Model No.: Unit Prefix; AEE, ASA, ATA, AYA, AEE-M, ASA-M, ERM, AXA, AET
Product Description: Industrial, Railway and Medical DCDC modules.

Reason(s) for Change: Branding Update to Advanced Energy and application of UKCA mark

Description of Change(s); Change of the module's branding from Astec or Artesyn Branding to Advanced Energy Branding
And the application of the relevant UKCA marking to the respective units

1 Brand per family Prefix

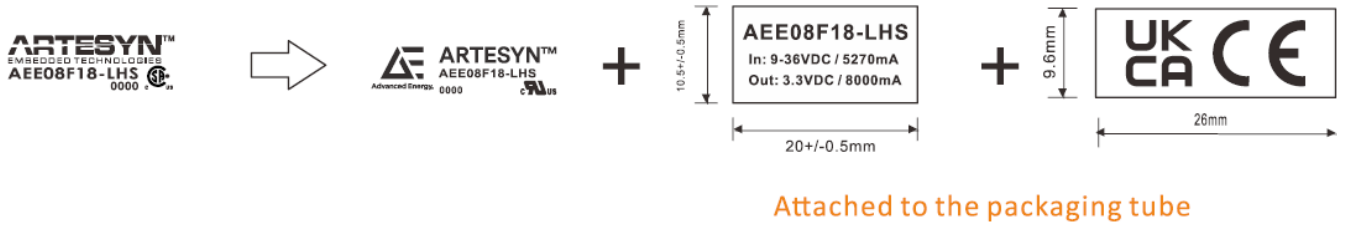
- AEE 40Watt family
- AEE-50Watt family
- AEE-M; Medical family
- ERM; All families

Example of the change;

3 Brand per family Prefix

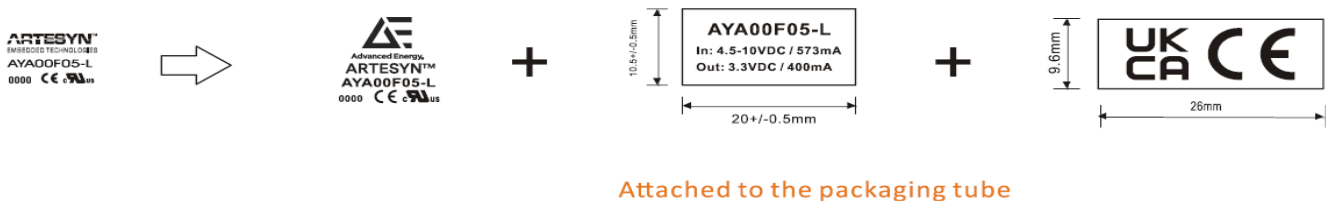
- AYA; All families

Example of the change

7 Brand per family Prefix

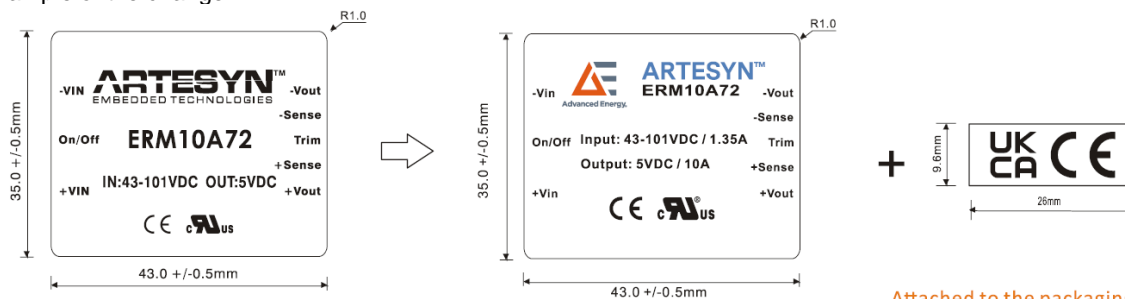
ERM10 family

Example of the change

Attached to the packaging tube
